CITY OF LA VISTA
MAYOR AND CITY COUNCIL REPORT
JULY 16, 2024 AGENDA

Subject:	Type:	Submitted By:
PUD SITE PLAN AMENDMENT – LOT 2 SOUTHPORT EAST REPLAT TWO	◆ RESOLUTION ORDINANCE RECEIVE/FILE	CHRISTOPHER SOLBERG DEPUTY COMMUNITY DEVELOPMENT DIRECTOR

RECOMMENDATION REPORT

RE: Planned Unit Development Amendment – Initial Review Letter
Lot 2 Southport East Replat Two

C3.0

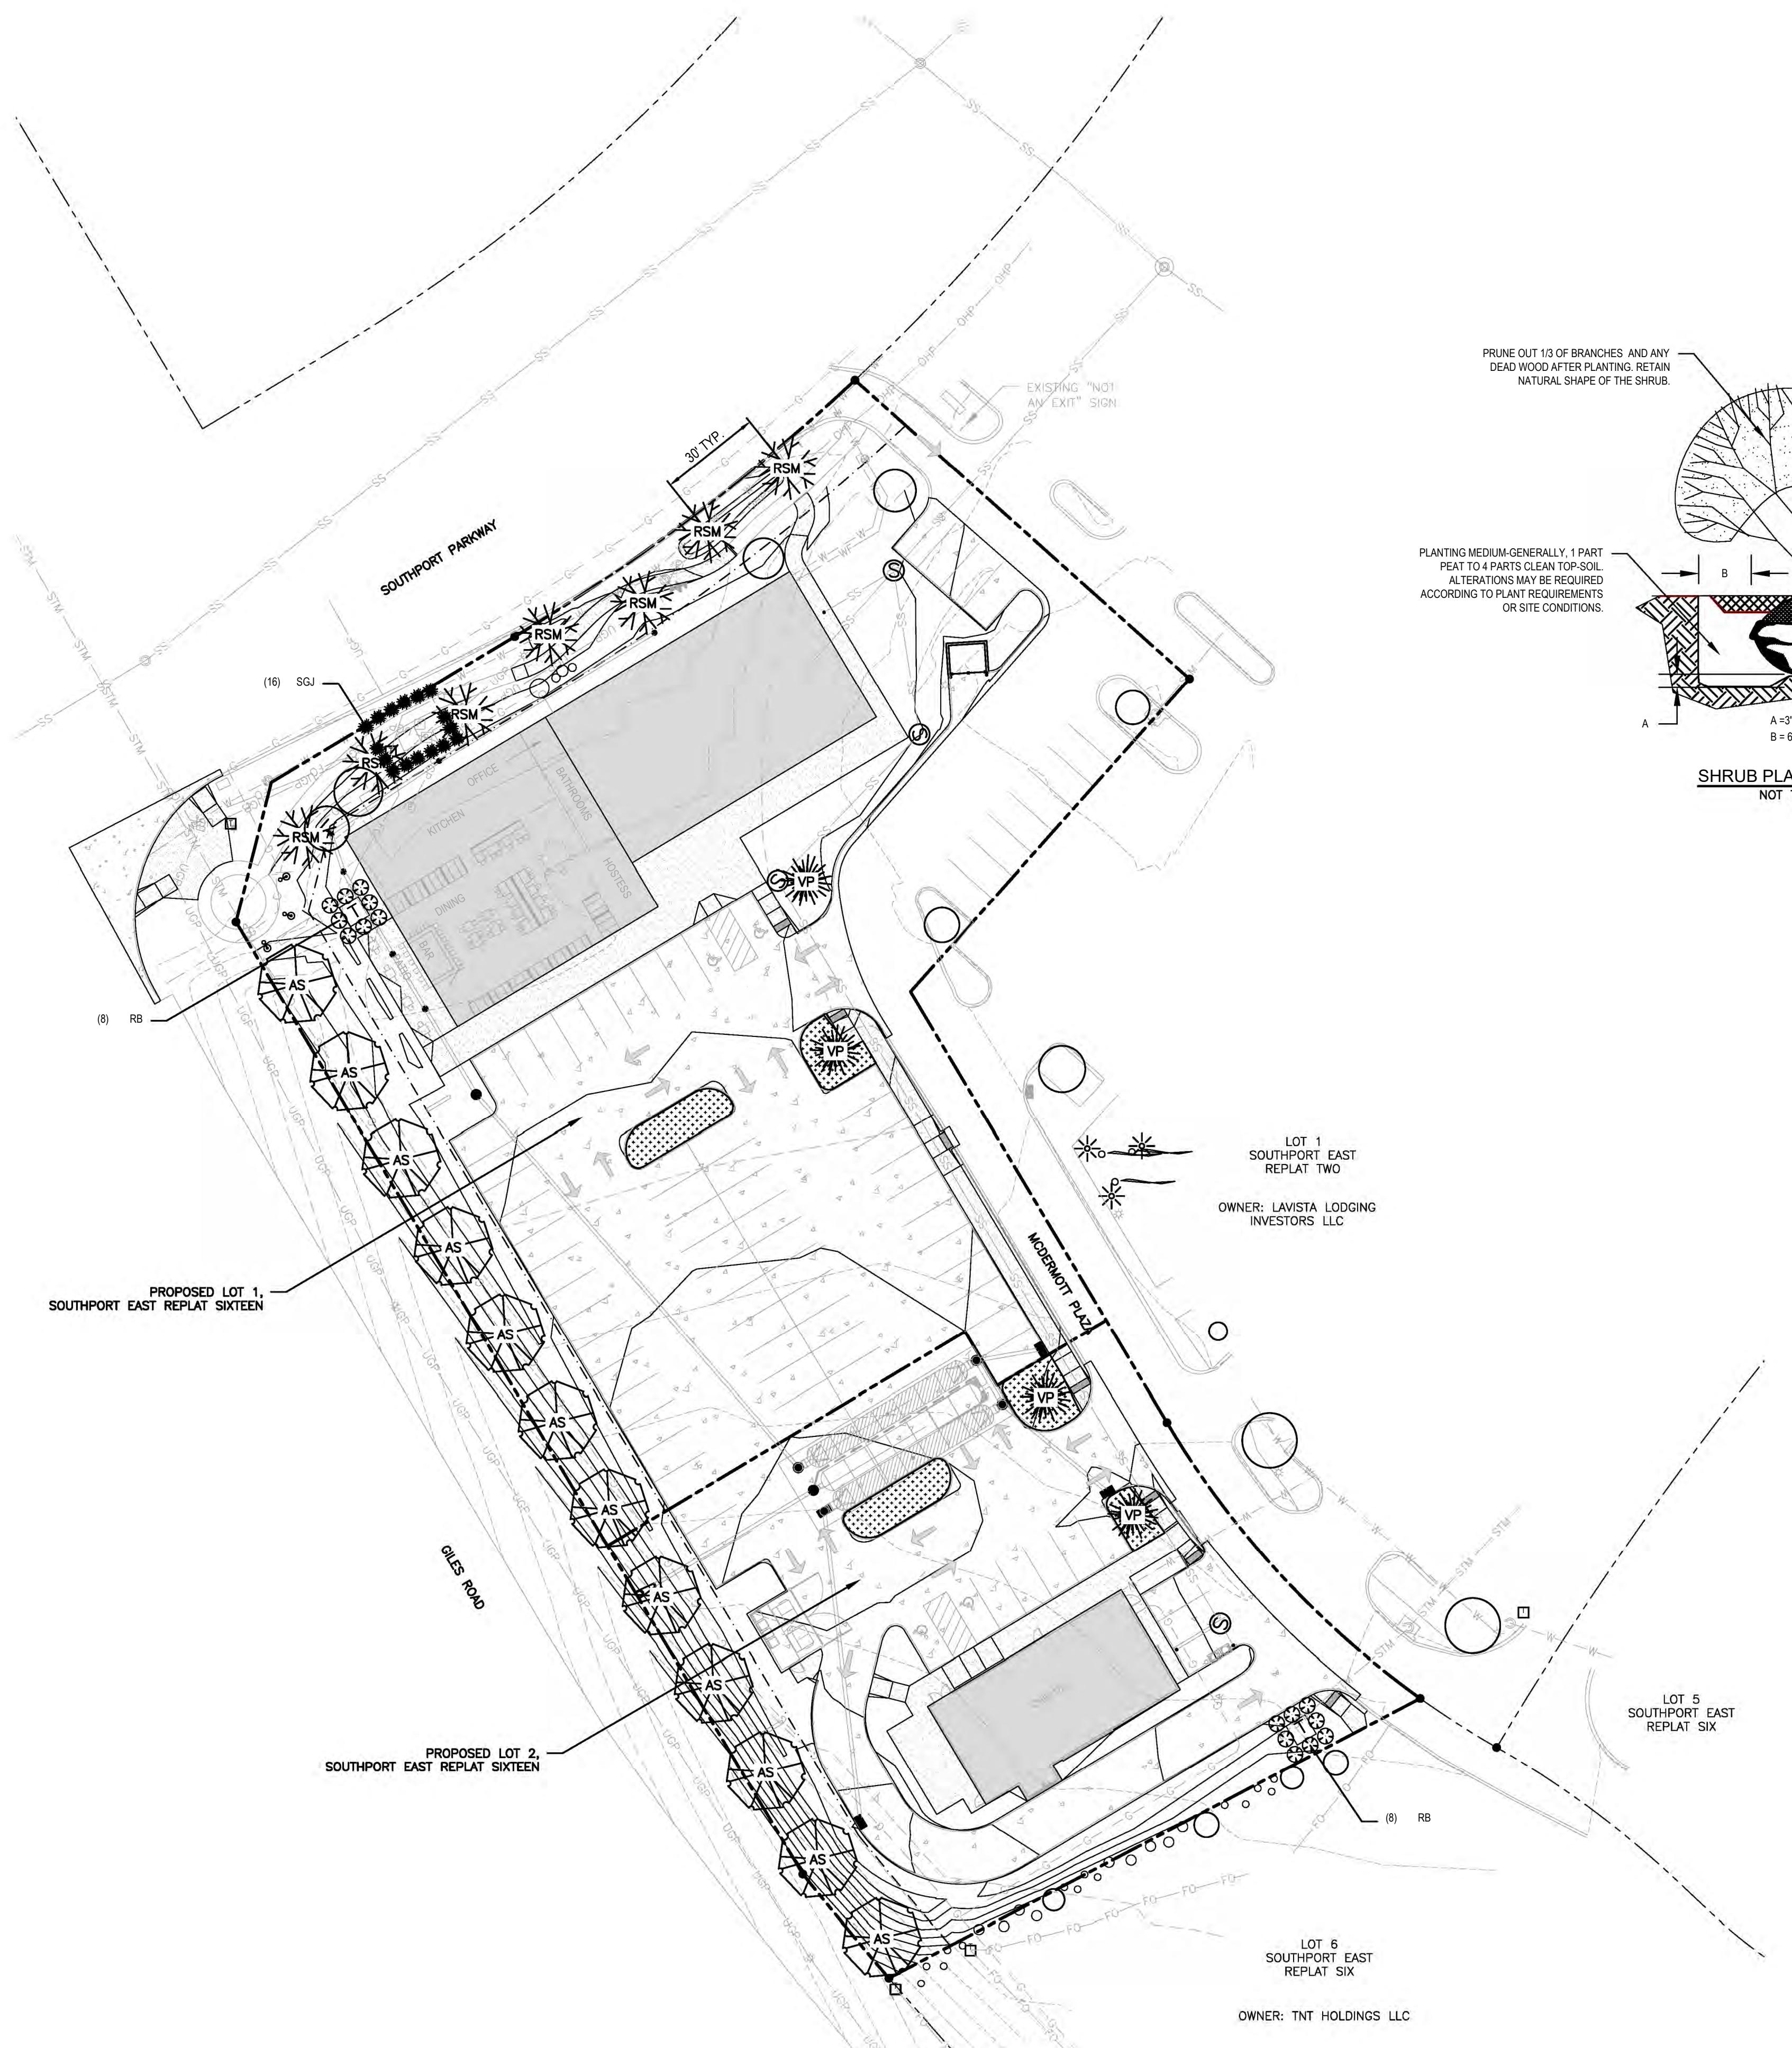
20. The proposed number and location of storm inlets appear to be inadequate. Please provide further details on how the parking lot will drain, per Section 5.15.05.04.
21. Please show the point of connection and other pertinent design information for the sanitary sewer, per Section 5.15.05.04.
22. Please show the point of connection and other pertinent design information for the to the public stormwater infrastructure, per Section 5.15.05.04.
23. Please show locations of natural features such as ponds, tree clusters, and drainageways, per Section 5.15.05.02.10.
24. Please submit a post-construction stormwater management plan, inclusive of a drainage study. In addition, a NPDES grading permit will be required at time of building permit.

10. Regarding Section 5.15.05.04, please be aware that manholes will be required at each change of alignment in the proposed sanitary sewer and that they must be accessible by maintenance vehicles at all times.
11. Please confirm the existence of the sanitary sewer where the proposed manhole connection is located.
12. Please provide for review a draft sanitary sewer easement in coordination with the property owner of Lot 1 Southport East Replat 2. A sanitary sewer easement will be required between Lots 1 and 2 for the conveyance of sanitary waste from Lot 2.

C4.0

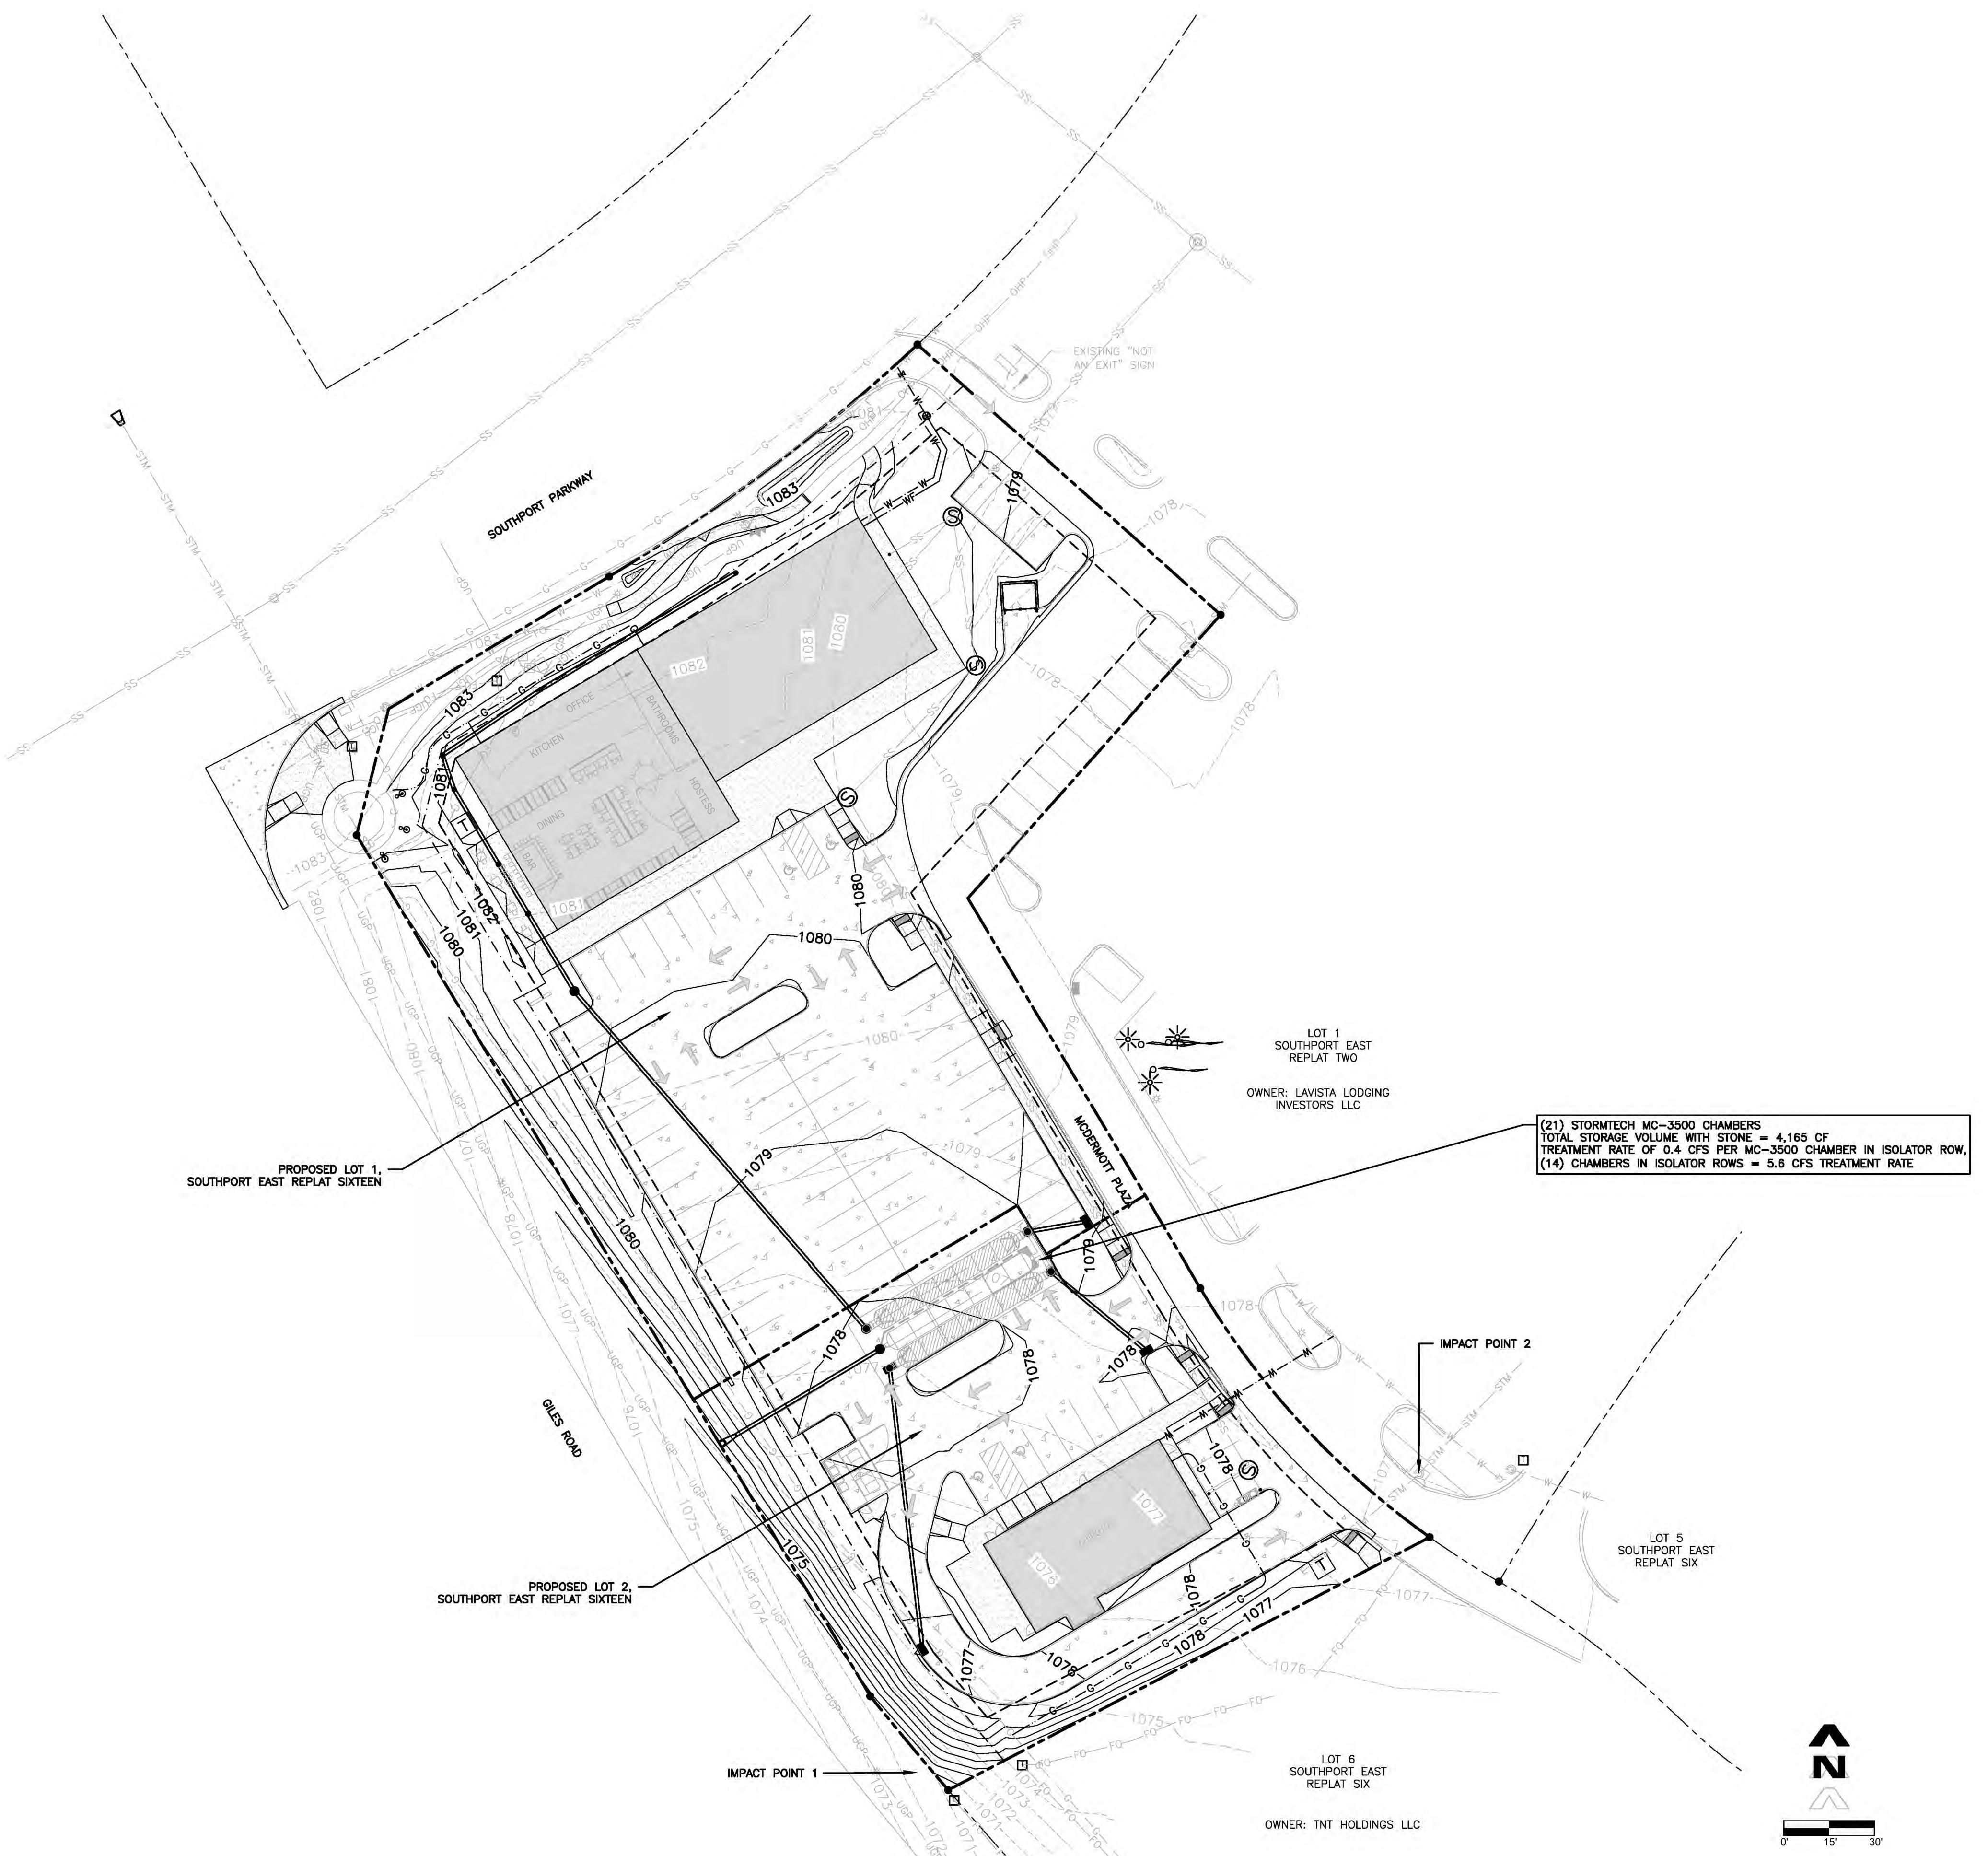
25. Pertaining to Section 5.15.04.08 of the La Vista Zoning Ordinance, the proposed landscaping plan is currently under review by the City's third-party design review architect. Landscaping for the development will need to meet the requirements of the Southport East Design Guidelines. Review comments will be provided when they are available.
26. Not all utility boxes are depicted along Southport Parkway. Please depict all boxes in the landscaping plan and related vegetative screening. Access doors to boxes cannot be blocked.

27. The landscaping plan does not depict the existing Center Identification Sign for the subdivision. Please depict this sign and adjust the location of any landscaping, as necessary.
28. No signage is depicted within any of the plans in this PUD plan set. Proposed ground monument signage locations, including setbacks, need to be depicted and landscaping should be adjusted accordingly.
29. Please make any necessary adjustments to the Landscaping Plan that may result from the introduction of the light poles.
30. Berming along street frontages is a requirement as per the Southport East Design Guidelines. Berming should be reflected in the PUD Grading Plan and the PUD Landscaping plan.
